IEEE P802.15
Wireless Personal Area Networks

Project	IEEE P802.15 Working Group for Wireless Personal Area Networks (WPANs)	
Title	TG3 D10 running comment resolutions	
Date Submitted	[8 July, 2002]	
Source	[James P. K. Gilb] [Apparent Technologies] [9921 Carmel Mountain Rd. #247, San Diego, CA 92129]	Voice: [858-538-3903] Fax: [858-538-3903] E-mail: [gilb@ieee.org]
Re:	[]	
Abstract	[This document is a record of comment resolutions for LB17.]	
Purpose	[To provide a record of the comment resolution for LB17.]	
Notice	This document has been prepared to assist the IEEE P802.15. It is offered as a basis for discussion and is not binding on the contributing individual(s) or organization(s). The material in this document is subject to change in form and content after further study. The contributor(s) reserve(s) the right to add, amend or withdraw material contained herein.	
Release	The contributor acknowledges and accepts that this contribution becomes the property of IEEE and may be made publicly available by P802.15.

2. Comment resolution in Schaumburg

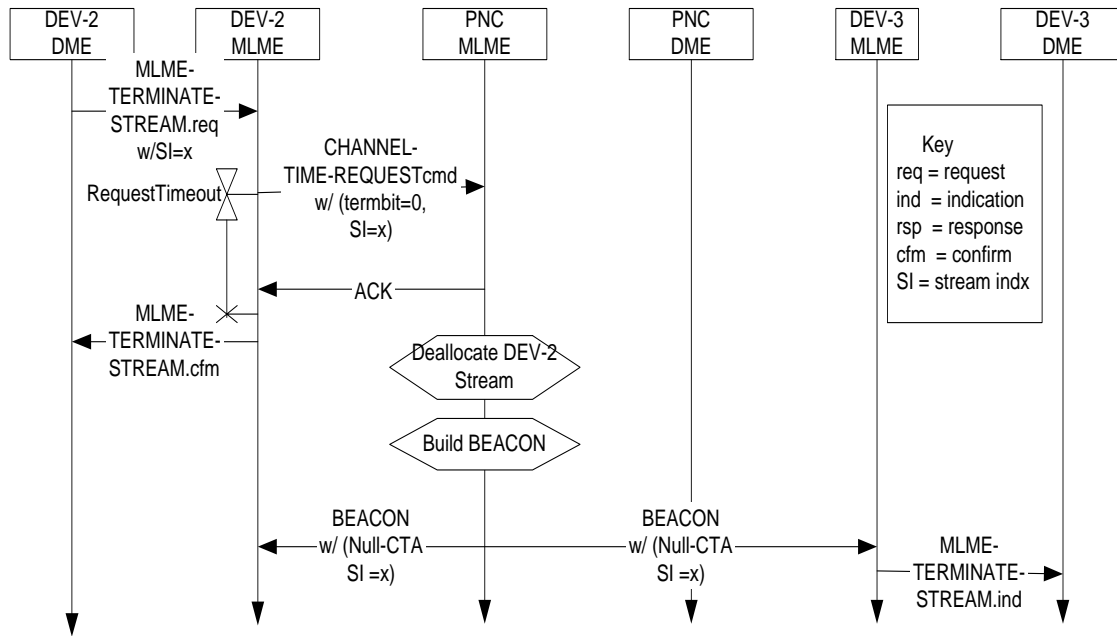
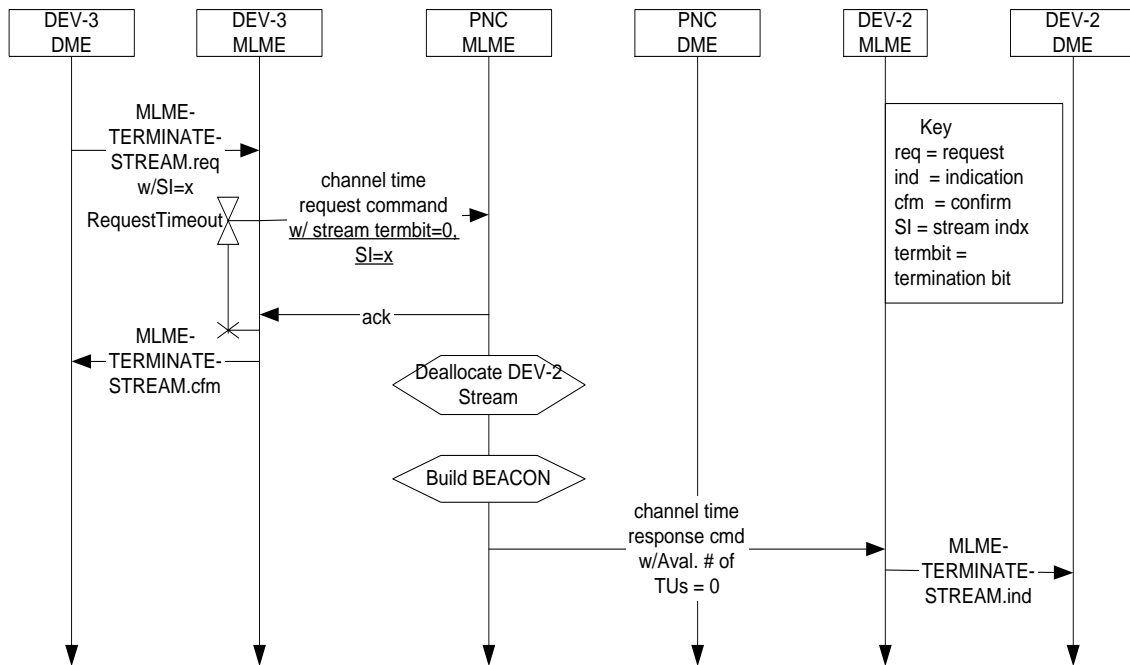
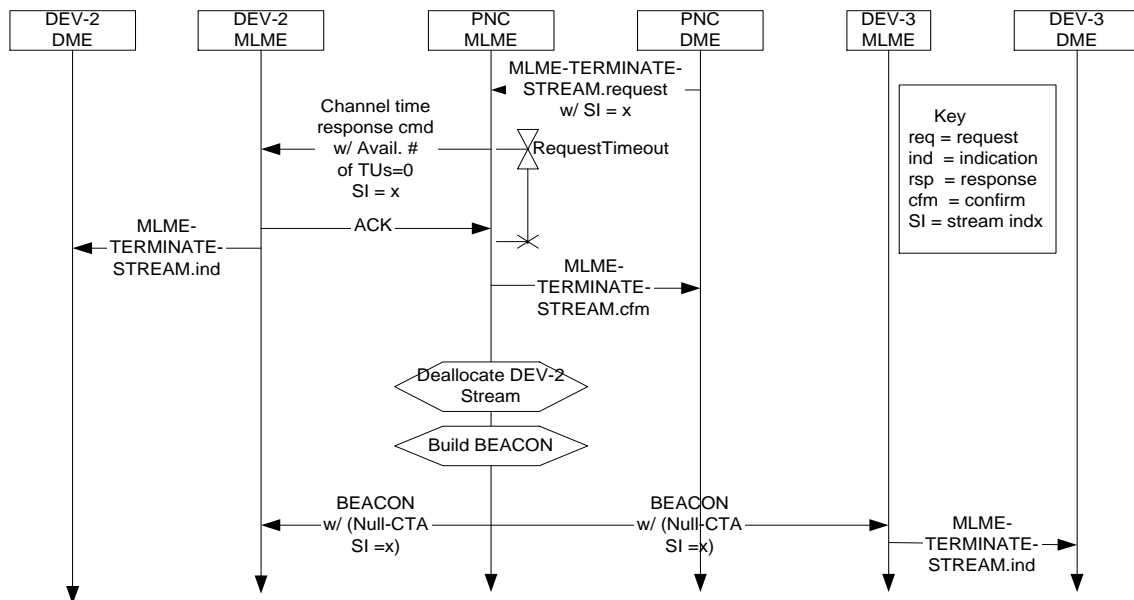
917 (Bain, TR) - The figures 117 and 118 should change to add the indication to PNC DME and to add the block noting the operation taking place in the PNC DME that allows the MAC and DME to be synched on resources. Other change needs to be in 6.3.14.10 and is a different comment. **Suggest reject** for these reasons: Fig. 118 is better represented by Fig. 102 which describes more precisely what happens when a DEV disassociates from the piconet and what the effect upon a stream would be. Fig. 117 do not require the required primitive since CIDs 155 and 364 describe a more efficient means of terminating a stream.

917 (Bain, TR) - The figures 117 and 118 should change to add the indication to PNC DME and to add the block noting the operation taking place in the PNC DME that allows the MAC and DME to be synched on resources. Other change needs to be in 6.3.14.10 and is a different comment. **Suggest reject** for these reasons: Fig. 118 is better represented by Fig. 102 which describes more precisely what happens when a DEV disassociates from the piconet and what the effect upon a stream would be. Fig. 117 do not require the required primitive since CIDs 155 and 364 describe a more efficient means of terminating a stream.

slot location and slot duration, {xref 7.4.8}. {xref Figure 16} illustrates the MSC for termination of a stream by a source DEV. In the case where the target DEV is requesting a stream termination, the PNC shall then notify the stream originating DEV of the termination via a channel time response command. {xref Figure 17} illustrates the MSC for termination of a stream by a target DEV.

In the case where the PNC decides to terminate a stream originating DEV's stream, the PNC shall notify the source DEV via a channel time response command and the target DEV via a null CTA in the beacon for aMinBeaconInfoRepeat duration. For CTAs that were not allocated every beacon, e.g. subrate slots, the null CTAs shall be placed starting in the beacon where the next CTA would have occurred and in the following {xref aMinBeaconInfoRepeat}-1 beacons. {xref Figure 18} illustrates the termination of a source DEV's stream by the PNC.

Figure 21—MSC for the initiating of a neighbor piconet.

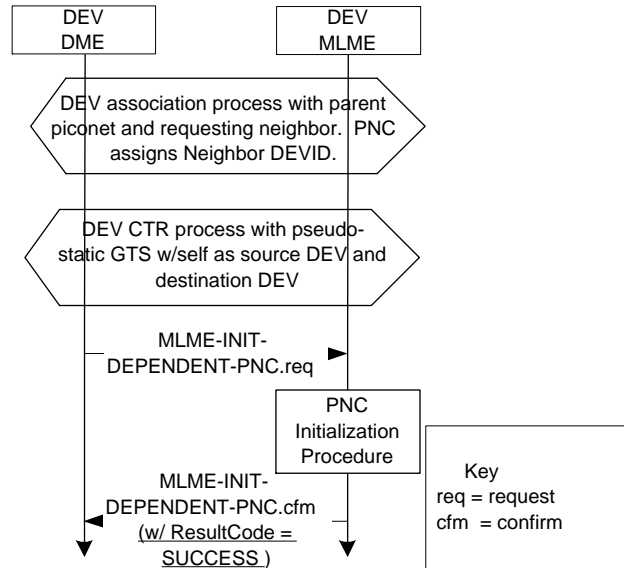
179 (Heberling, TR) - Figure 98 should be replaced with a proper MSC of the required protocol needed to establish a neighbor piconet. Replace figure 98 with a proper MSC. **Suggest accept** - An MSC for neighbor piconet initialization is included below. It needs twiddling to get the vertical lines to not show in the hex process blocks. Also, although consistent with other similar diagrams, this MSC seems to need the first beacon of the neighbor PNC shown.

Accept in principle, “Accept suggested resolution but add a line at the bottom that shows the first beacon being sent. Also add after the sentence that says ‘The MSC for the initiation a neighbor piconet is illustrated in Figure 21.’ the following sentence, ‘The association and channel time request processes are defined in xref and xref, respectively.’”

Figure 22—MSC for the creating a child piconet.

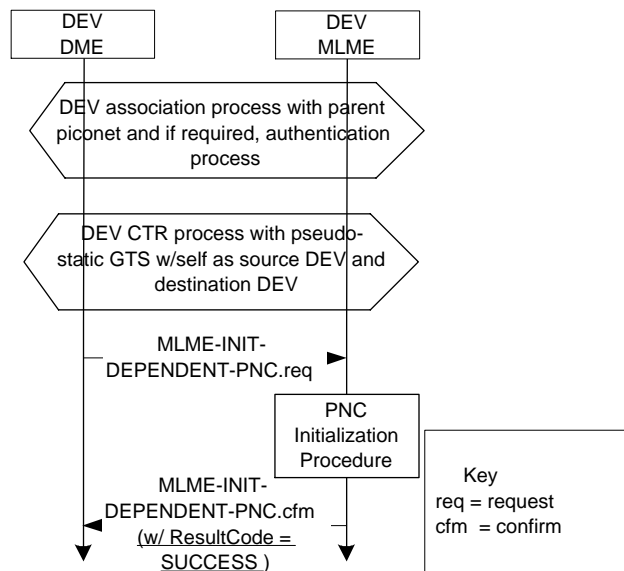
177 (Heberling, TR) - Figure 96 should be replaced with a proper MSC of the required protocol needed to establish a child piconet. Replace figure 96 with a proper MSC. **Suggest accept** 'An MSC for child piconet initialization is included below. It needs twiddling to get the vertical lines to not show in the hex process blocks. Also, although consistent with other similar diagrams, this MSC seems to need the first beacon of the child PNC shown.

Accept suggested resolution but add a line at the bottom that shows the first beacon being sent. Also add after the sentence that says 'The MSC for creating a child piconet is illustrated in Figure 22.' the following sentence, 'The association and channel time request processes are defined in xref and xref, respectively.'

Figure 23—MSC for a approved asynchronous channel time request

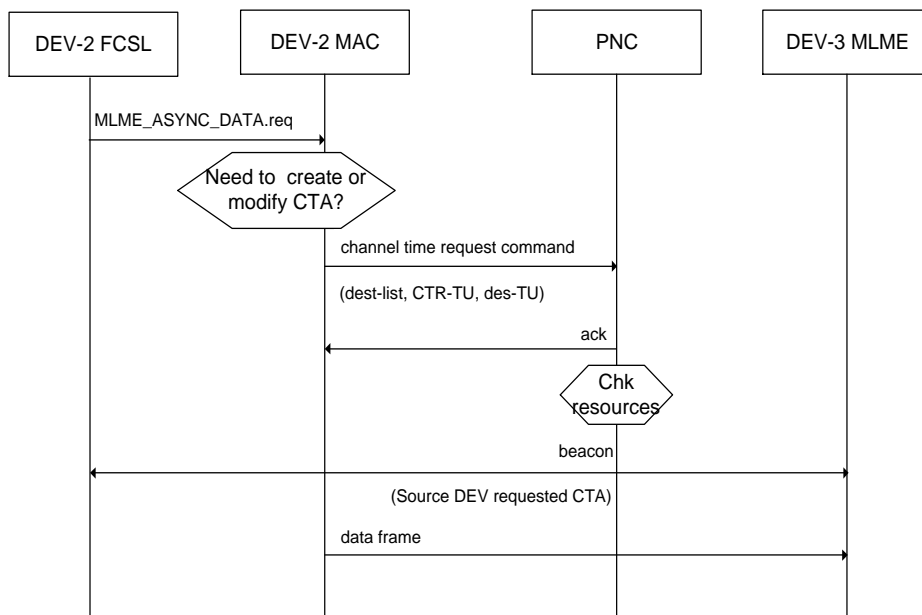
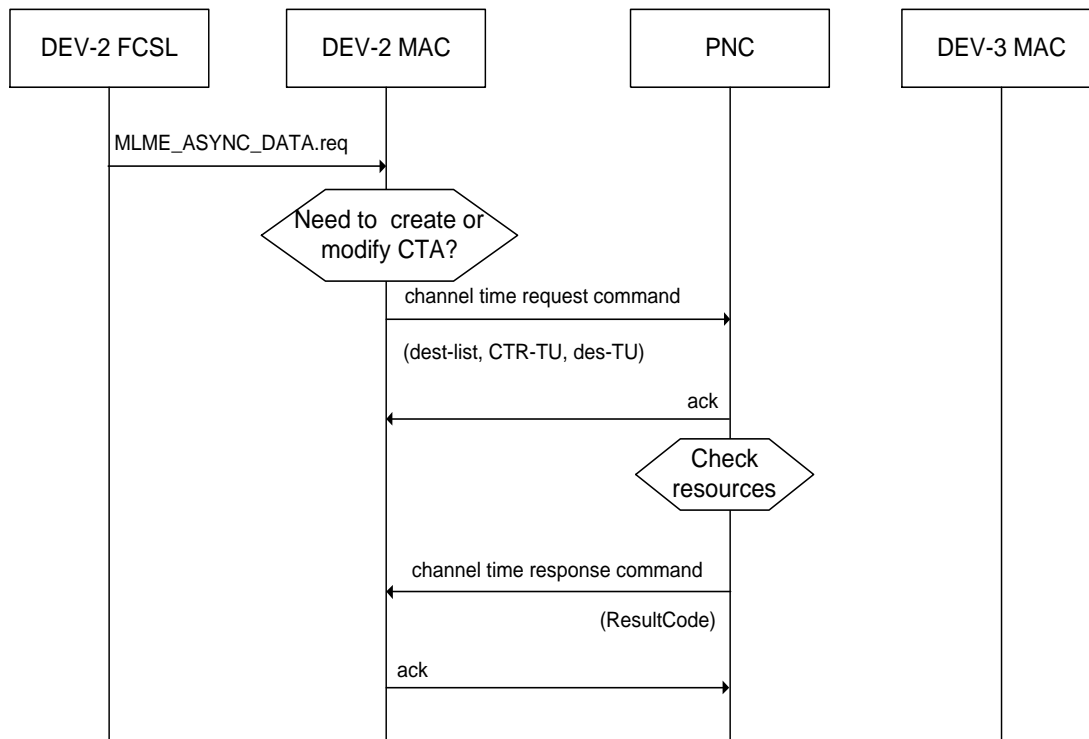
327 (Heberling, TR) Figure 119 is a flawed MSC of the Asynchronous channel time reservation process and data frame exchange. Consequently, delete the current MSC from this section of clause 8.5.2.1 and replace it with 02r0P802-15_TG3-Asynch-channel-time-allocation.eps. **Suggest accept.**

<Page 182, Figure 119> – MSC for reserving asynchronous data channel time. Discussed earlier, new MSC is below (needs work to match the other MSCs in the clause.):

ple 1) replace MAC-Q and MLME with simply DEV-2 MAC. 2) Rename Packet CL to FC SL 3) Delete Figure 4 since it is duplicated in Figure 119. 4) Incorporate suggested changes identified in CID 327
